TOWN OF ERIE
PLANNING COMMISSION AGENDA ITEM
Board Meeting Date: March 1, 2017

SUBJECT:	GENERAL BUSINESS:
	A Sketch Plan Review of Flatiron Meadows Planning Area H
CODE REVIEW:	Erie Municipal Code, Title 10
PURPOSE:	A Sketch Plan represents a generalized land use plan and layout for the area proposed to be included within a subdivision. A Sketch Plan application is required to allow for an early, informal evaluation of a proposed subdivision before detailed planning and engineering work has occurred.
DEPARTMENT:	Community Development
PRESENTER:	Todd Bjerkaas PLA, Senior Planner

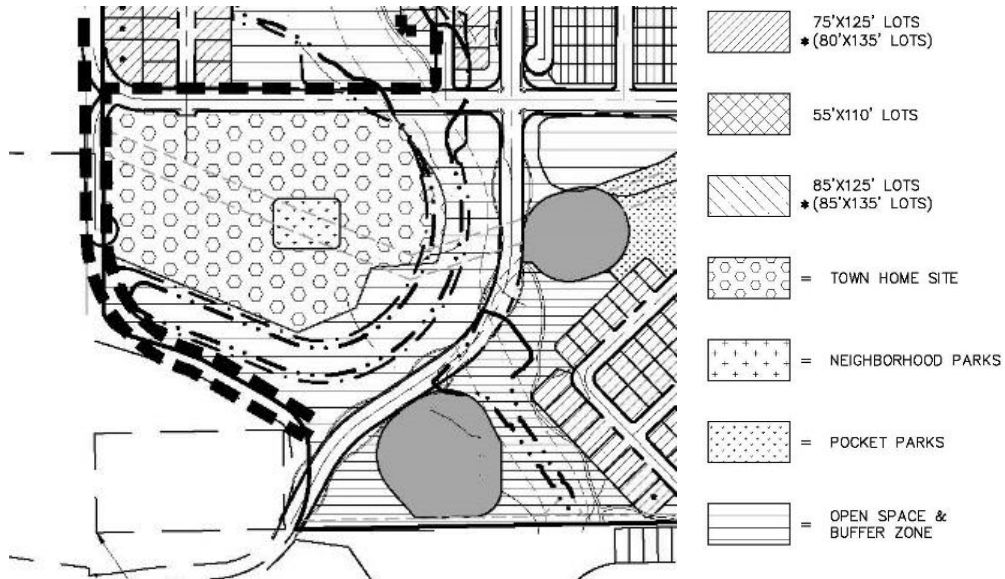
The development features single-family attached lot types in the configuration of alley-loaded paired homes. Most lots would face interior common green spaces or adjacent open space.

Only the north facing lots on the southern stretch of the loop street are oriented directly to a street. Two access points are proposed from N. 111th Street (which will be reconstructed) and form a loop road for access through the SR-5 area.

A Pocket Park, as required by the Preliminary Plat (see enlargement below), is located within this sketch plan at its southeast edge adjacent to open space. A local trail on the north side of the area would connect into the single-family detached lots to the north. That trail would also provide a trail connection to the east, across the drainage way, and to the newly constructed Spine Trail.
